CASE COMMENT REPORT

CASE NO. UDP-S24072

CASE	UDP-S24072
PROJECT NAME	Broward Health Medical Center (BHMC) Medical Office Building and Parking Garage
APPLICATION TYPE	Site Plan Level II
APPROVAL LEVEL	City Commission Approval
REQUEST	Design Deviations for Additional Building Height Greater than 110 Feet in Height for 204,589 Square Feet of Medical Office Use
APPLICANT	North Broward Hospital District
AGENT	Stephanie Toothaker, Esq.
PROPERTY ADDRESS	1601, 1603, 1611, 1627, and 1632 S. Andrews Avenue
ABBREVIATED LEGAL DESCRIPTION	Croissant Park Resub Blk 38 52-8 B Lots 1 To 12, 17 and 18, 21 To 24
ZONING DISTRICT	South Regional Activity Center-South Andrews east (RAC-SAe)
LAND USE	South Regional Activity Center
COMMISSION DISTRICT	4 - Ben Sorensen
NEIGHBORHOOD ASSOCIATION	Poinciana Park Civic Association
SUBMITTAL	December 13, 2024
COMPLETENESS ISSUED	December 19, 2024
EXPIRATION	June 17, 2025 (180 Days)
WAIVER	Not Requested
CASE PLANNER	Adam Schnell Urban Planner III

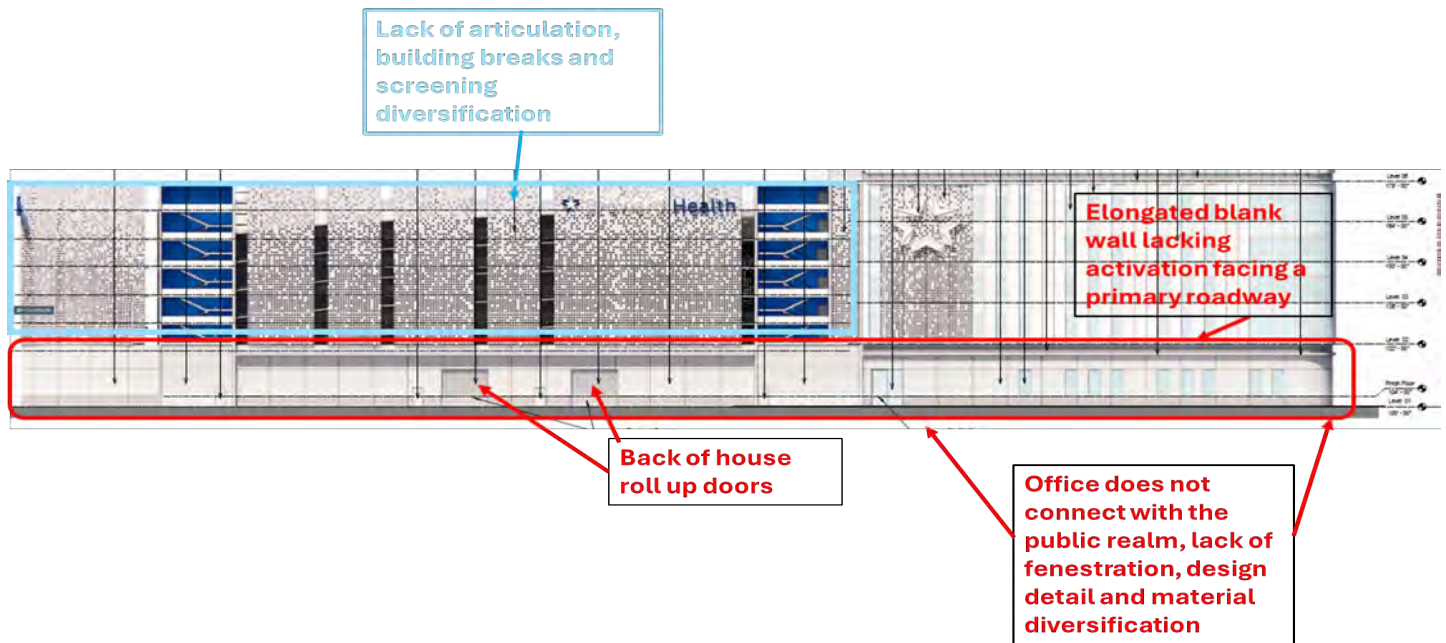
- o. Per the SRAC Master Plan the maximum travel lane width shall be ten feet. Increase the sidewalk and swale width of SW 1st avenue and remove the drop-off lane that encroaches into the public right-of-way, as well as any sidewalk pinch points. With the removal of the drop-off lane additional trees can be provided. Because no on-street parking is being provided, an approximate 12-foot-wide unobstructed sidewalk can be provided, with a 10-foot-wide landscape swale, and two-foot curb and gutter. Reference image below for additional context. Note: Consider internalizing the drop-off between the existing and proposed building on the vacated portion of SW 16th Street. Reference the image below for additional context.

SE/SW 17th Street Intersection

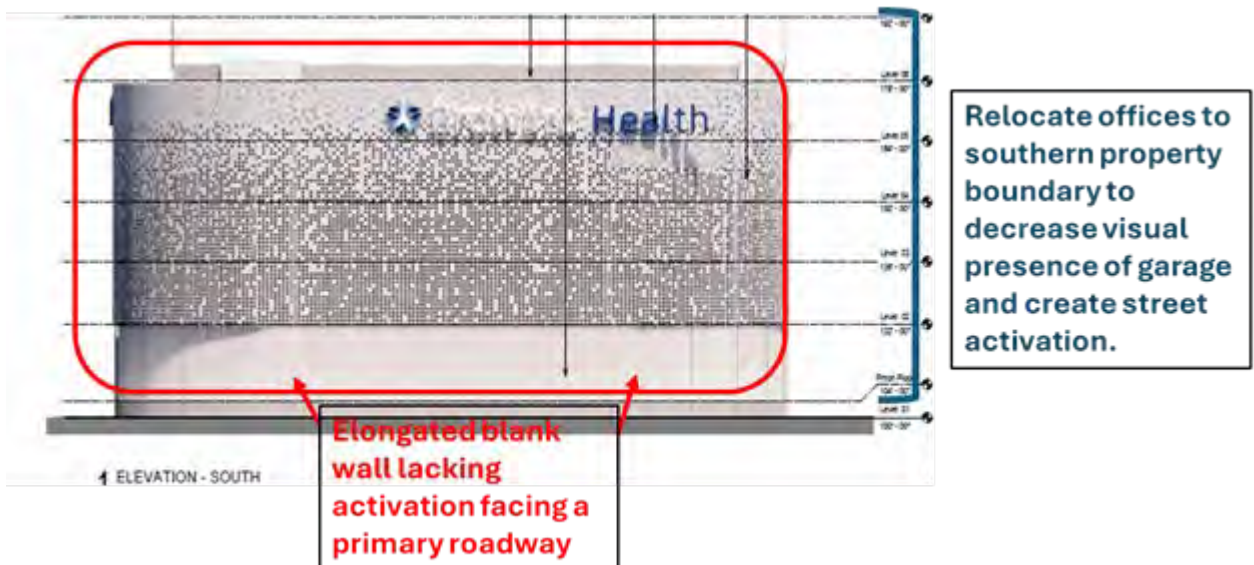
- e. The treatment of the ground level façade on South Andrews Avenue is cement plaster, roll up metal doors, utility access and nine windows and the frontage of SE/SW 17th Street is a parking garage with a 22 foot high blank cement plastered wall, running over 100 feet in length, with no building access, articulation, or change in material. First floors shall have a minimum height of fifteen (15) feet, and a high percentage of clear glazing (Primary Streets – minimum, 60% and Secondary Streets – minimum 50%). The first floor does not meet clear glazing requirements. Provide additional floor to ceiling windows, first floor active uses along the southern and eastern elevations, limiting back of house uses to the northern and western elevations, and use diversified high-quality material at the ground level to differentiate the pedestrian experience from the garage element.
